Subject: MHI's Response to US-APWR DCD RAI No. 297-2287 Revision 2

MHI's Response to US-APWR DCD RAI No. 297-2287 Revision 2

**US-APWR Design Certification
Mitsubishi Heavy Industries
Docket No. 52-021**

RAI NO.: NO. 297-2287 REVISION 2
SRP SECTION: 15 – INTRODUCTION – TRANSIENT AND ACCIDENT ANALYSES
APPLICATION SECTION: 15.0.0
DATE OF RAI ISSUE: 5/04/2009

**Figure 15.0.0-3.16 Hot Spot Heat Flux versus Time with and without LOOP
Steam System Piping Failure
- Case C: Limiting case for spectrum of breaks at 100% power**

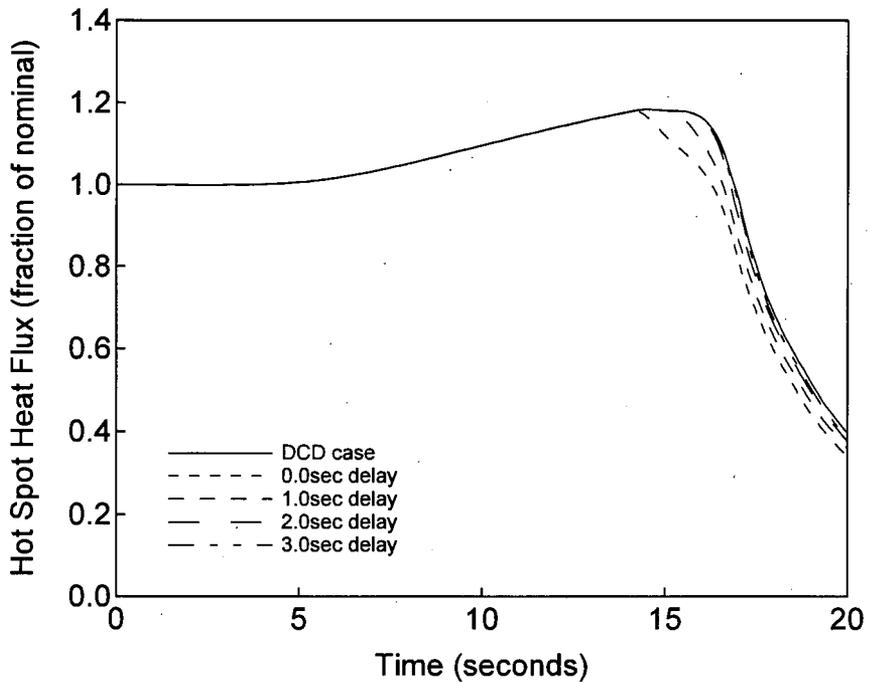
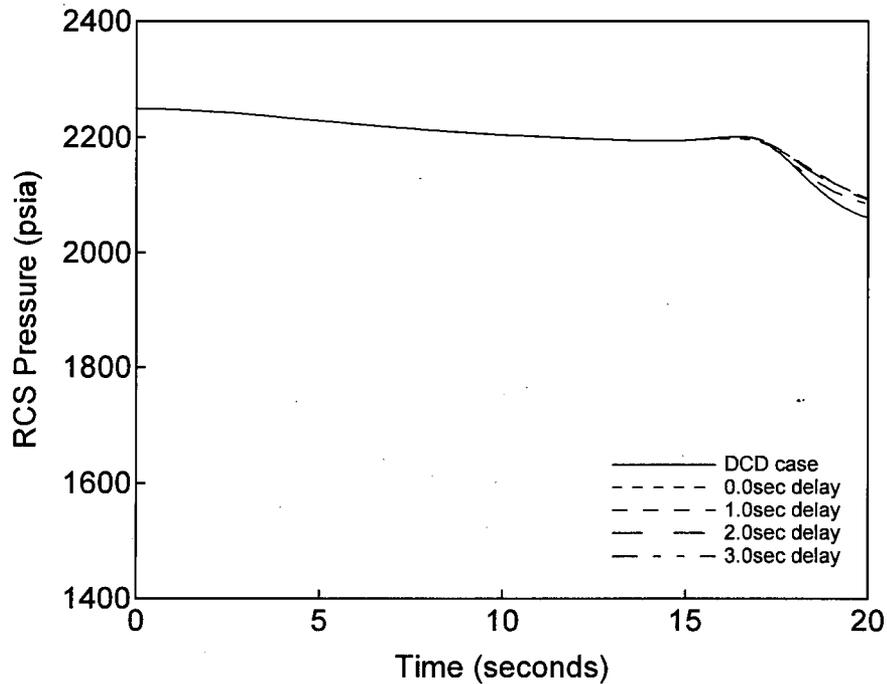
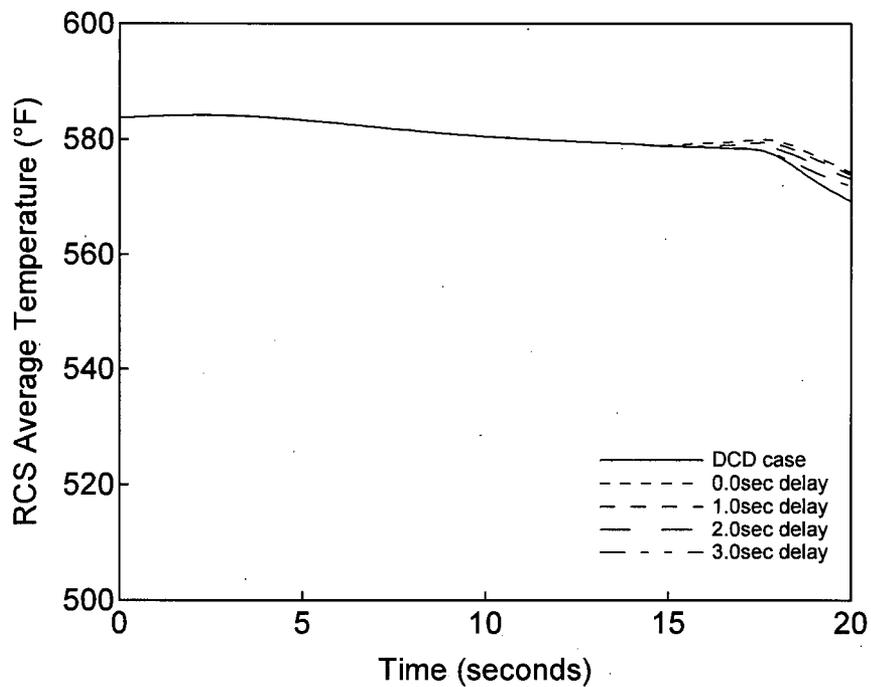
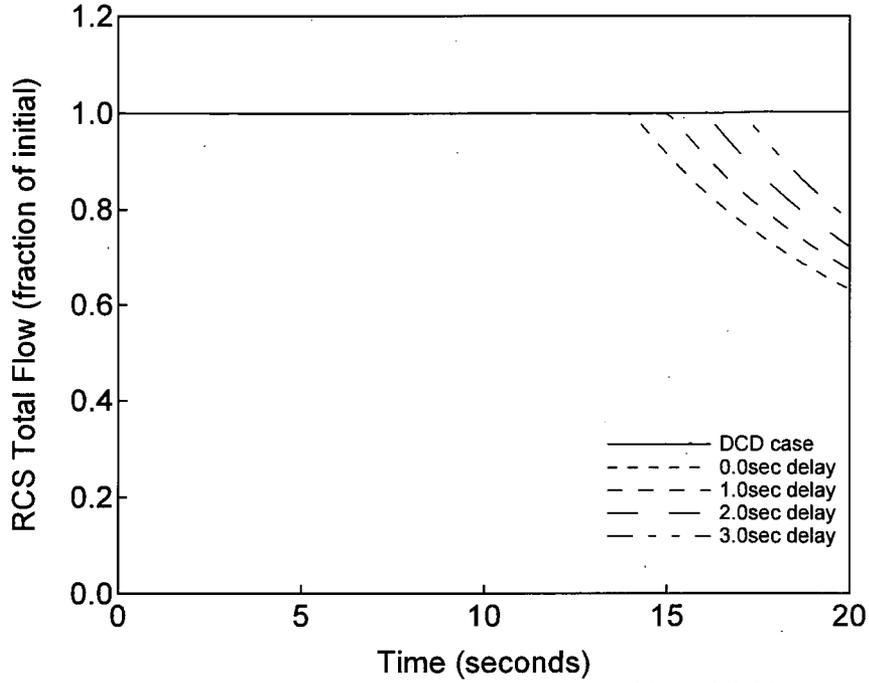
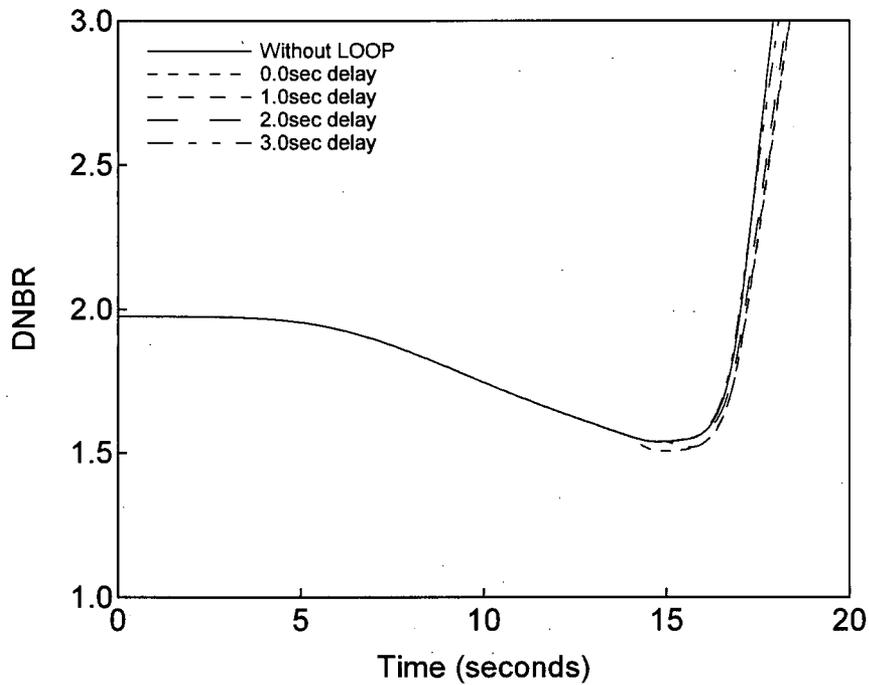
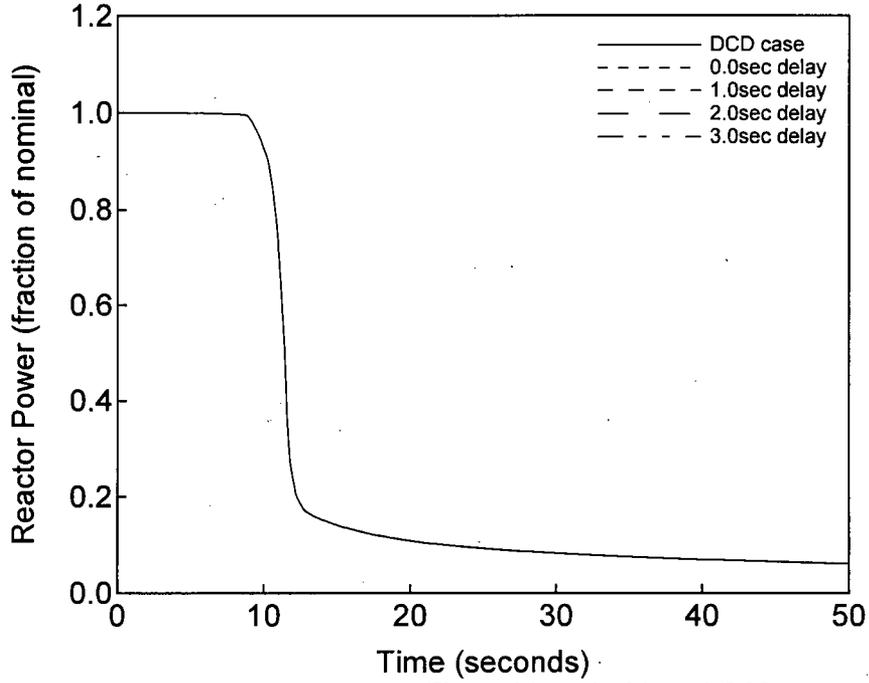
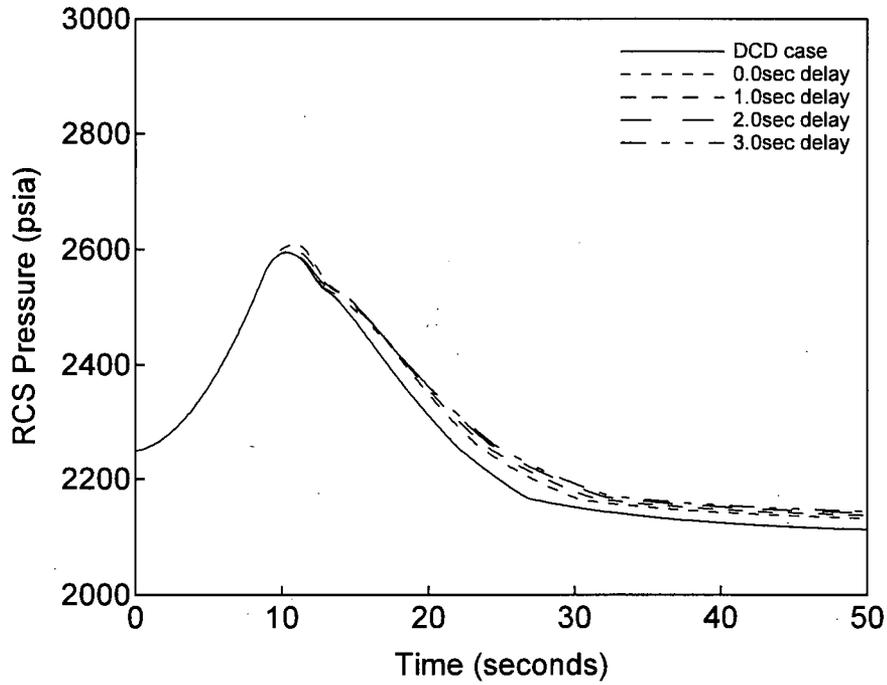
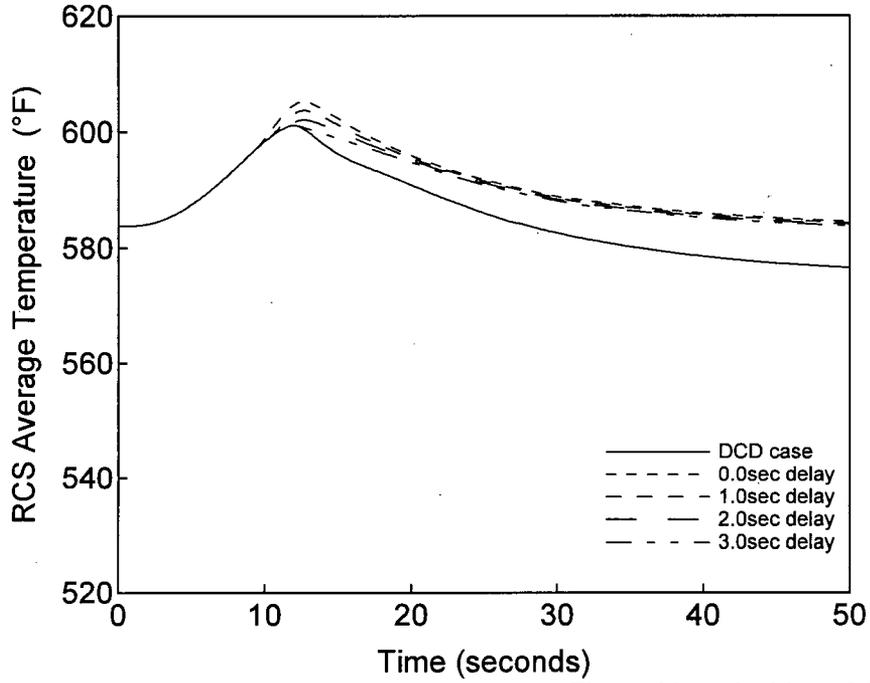
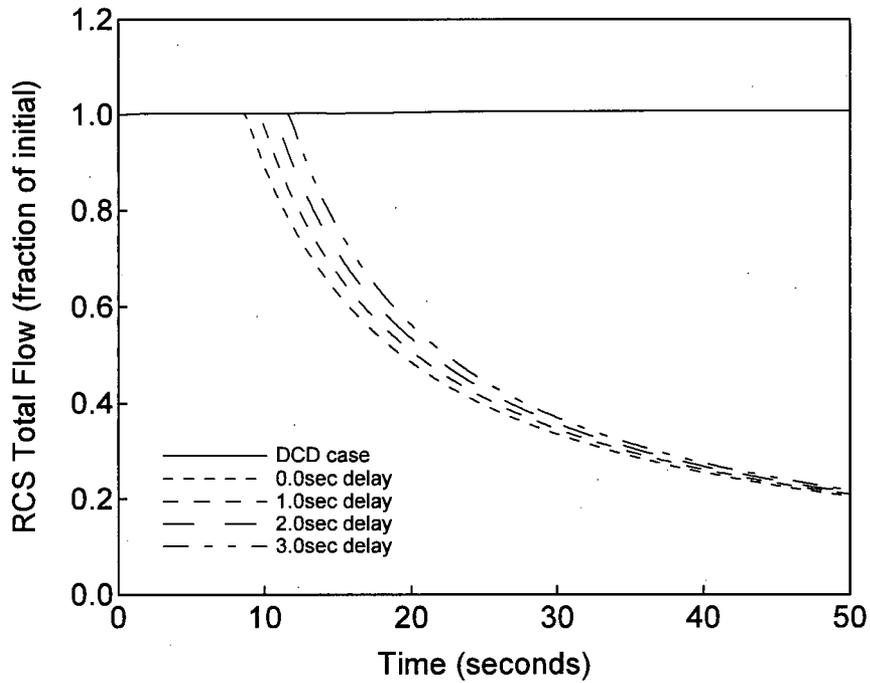
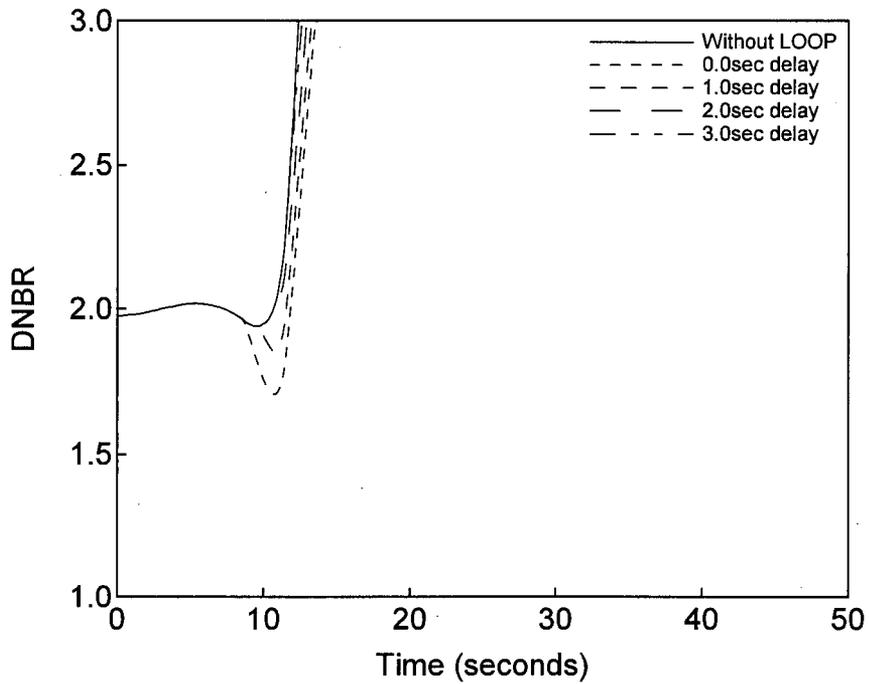
In DCD Section 15.0.0.7, the applicant presents arguments concerning the timing of a LOOP with respect to the timing of reactor trip and RCP coast down. By assuming a time delay in the onset of a LOOP, the onset of DNBR is decoupled from the availability of offsite power because the rods are inserted to the dashpot by the time the LOOP is initiated; therefore, the RCPs continue to run until the rods have been inserted in the core. This argument repeats itself throughout many Chapter 15 scenarios, allowing for the neglect of any LOOP consequences. Please provide more substantial arguments in defense of this assumed time delay, supported by sensitivity calculations that directly address this issue. (see also Question 15.1.2-1).

As described in DCD Subsection 15.0.0.7 and the response to Question 15.0.0-2 of this RAI, the US-APWR DCD Chapter 15 analyses currently assume a loss of offsite power (LOOP) occurs a minimum of 3 seconds after the reactor trip. This 3-second delay accounts for the time it would take for a grid instability caused by the turbine-generator trip due to the reactor trip to propagate through the grid to the plant offsite power source. A turbine-generator trip without a prior reactor trip is also assumed to ultimately cause a LOOP with the same 3-second delay time.

The results of the DNBR sensitivity analysis of these four events validate the assumption described in DCD Subsection 15.0.0.7 (and reiterated in event-specific subsections) that, with a 3 second delay between the turbine-generator trip and LOOP, the minimum DNBR is the same for the case with and without LOOP. The results of this sensitivity also show that there is some available margin in the delay time assumed since the minimum DNBR is the same for the case with LOOP assuming a 2 second delay and without LOOP. In addition, while the minimum DNBR for the 1 second delay cases were slightly worse than the cases without LOOP, the DNBR remained above the safety analysis analytical limit. Since the four events selected for this sensitivity analysis were representative DNBR events in Chapter 15, the remaining DNBR analysis in Chapter 15 would also be adequate even assuming a 1 second delay (excluding those events that already violated the DNBR limit, such as the RCP rotor seizure). Although the results showed that the two 0 second delay RWP cases result in a minimum DNBR below the acceptance limit, the US-APWR DCD contains COL Item 8.2(11) which requires that the COL applicant perform a grid stability analysis to confirm that the LOOP occurs at 3 seconds or greater. This is also described in the response to Question 15.0.0-4 of this RAI.
